## Change Order Request

**Project:** 1923025-02  
La Crosse Center Expansion & Renovation  
400 La Crosse Street  
La Crosse, WI 54601

**COR #** 272.00

**PCO #** 390 - Epoxy Alcoves

**3A1-42**

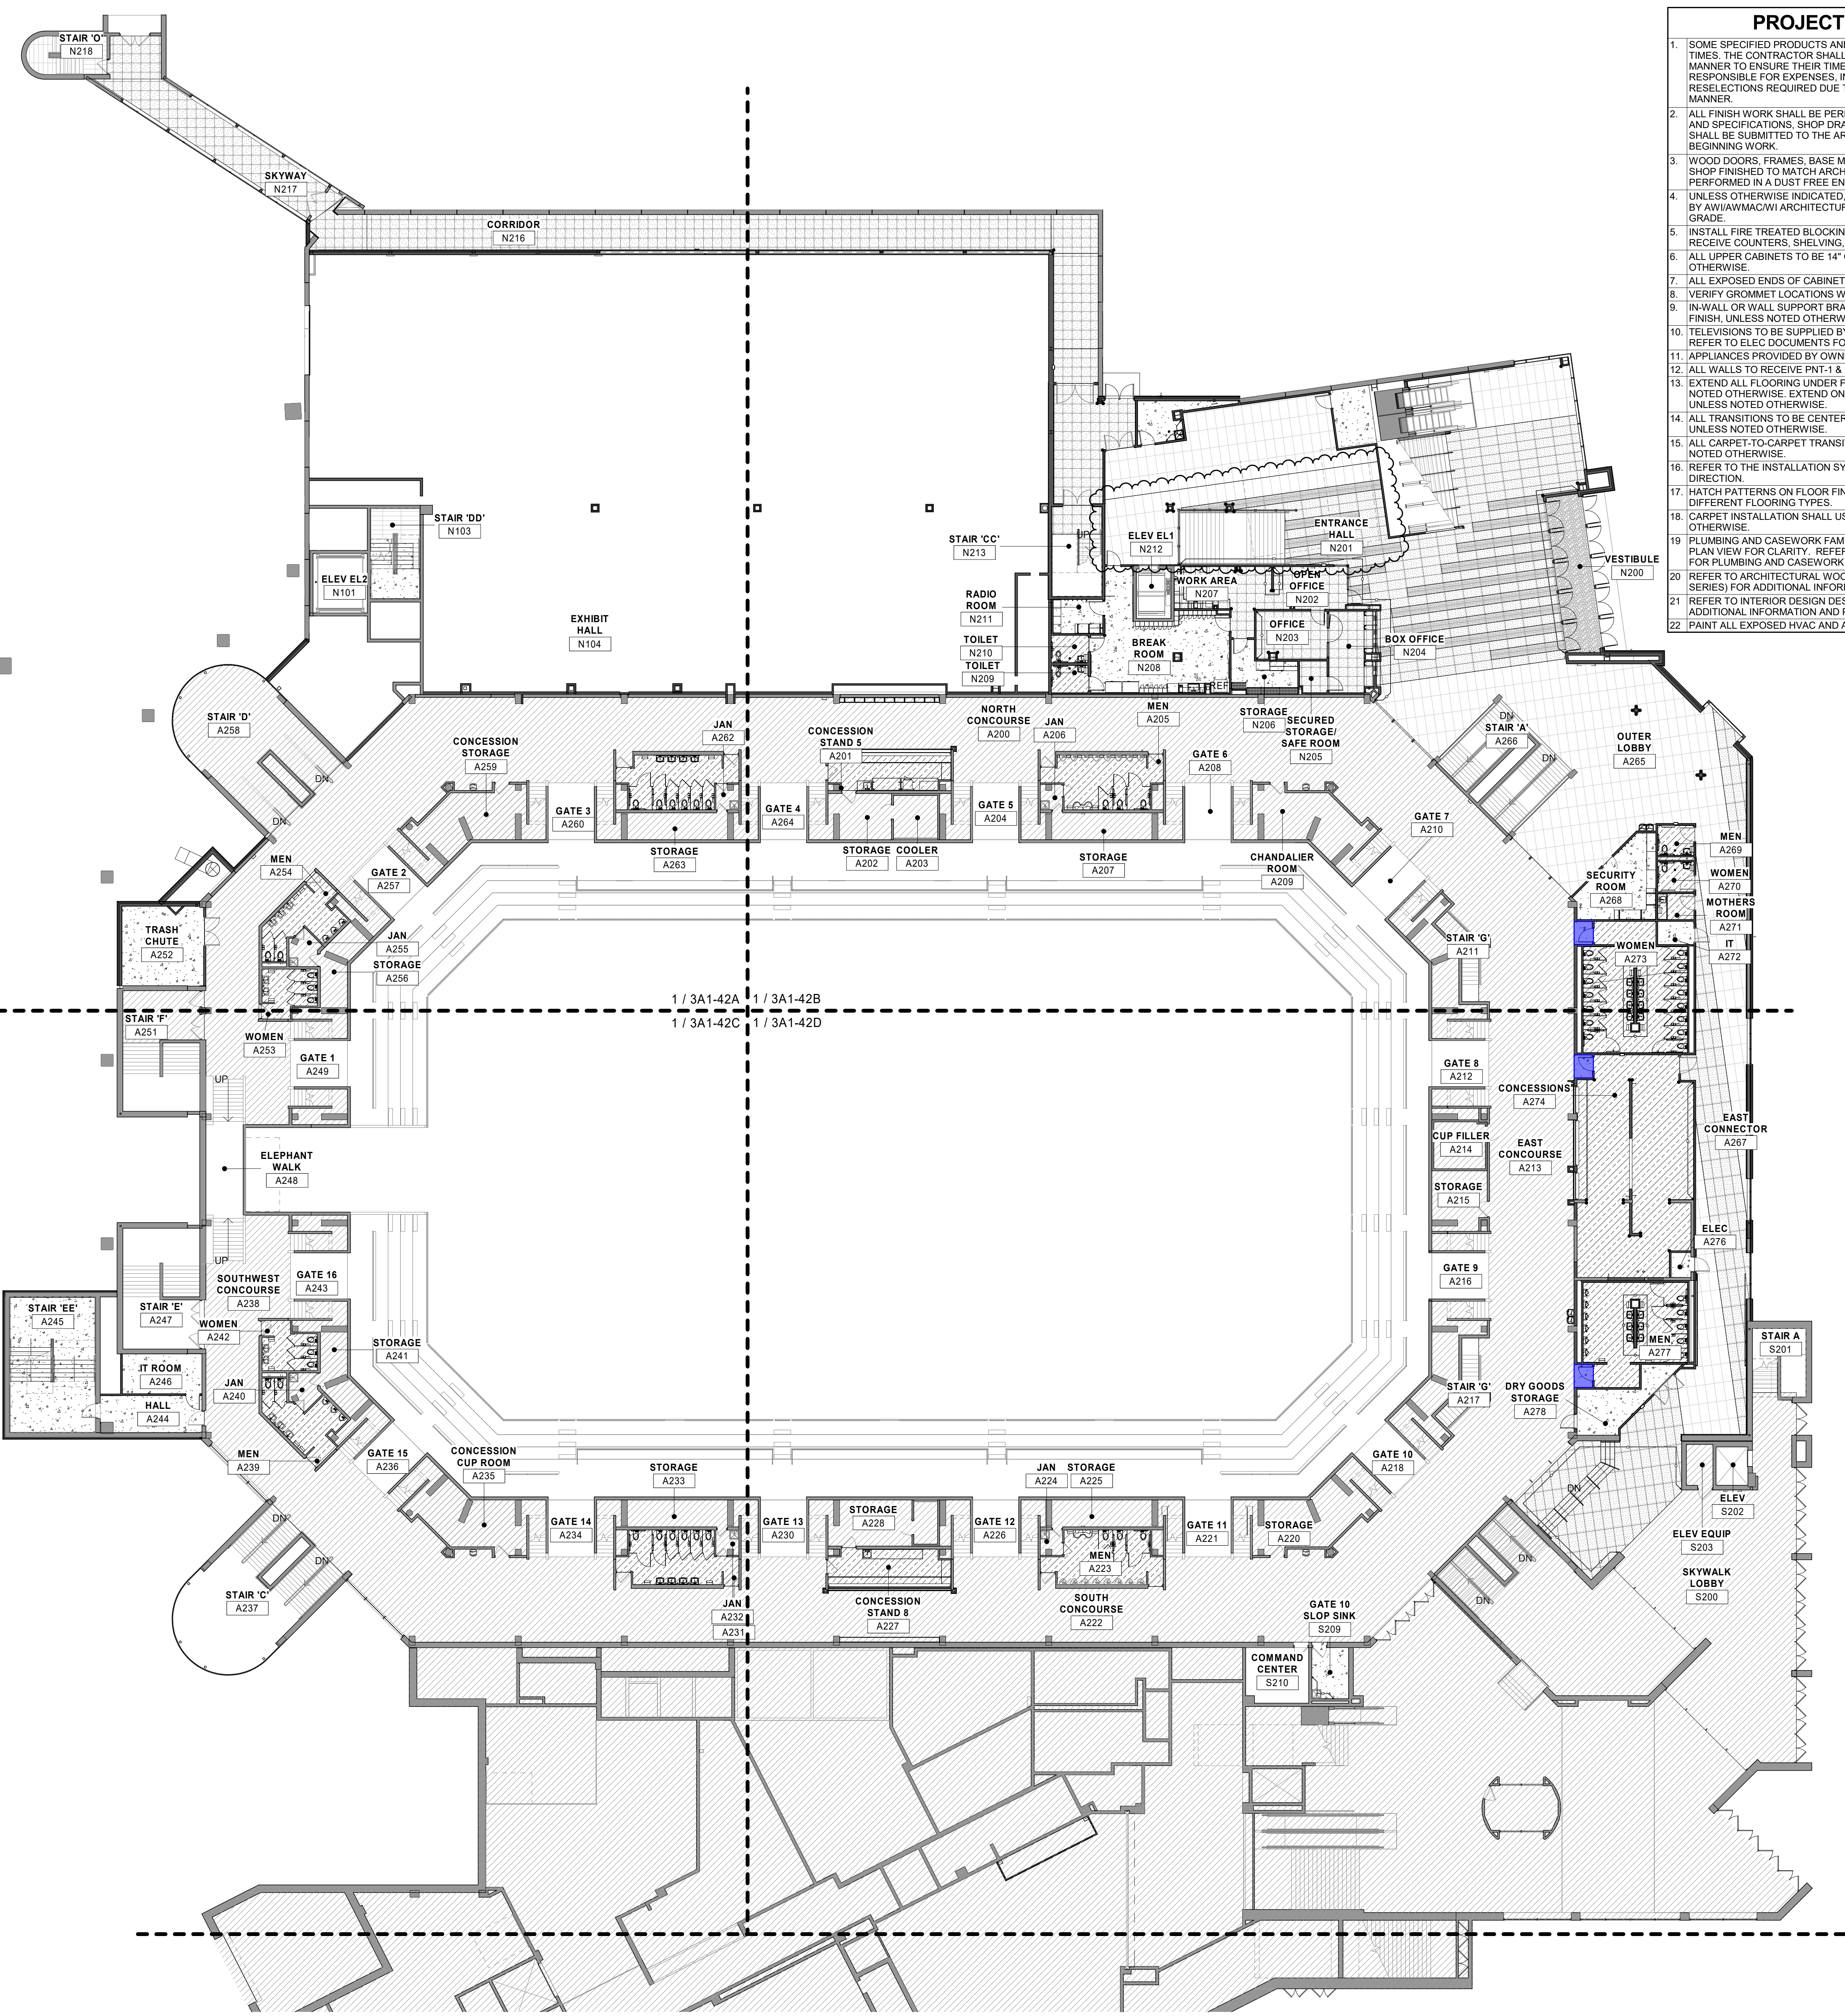
P.O. No.	Project
Description	Qty	Cost	Total
The 3 locations that are 4x5 will be shotblasted and diamond ground to ICRI CSP #3 for proper coating adhesion. We will install an epoxy primer, followed by a grout coat, and finish with a high traffic urethane topcoat. These locations will be medium gray in color.	1	3,595.00	3,595.00
		<b>Total</b>	\$3,595.00
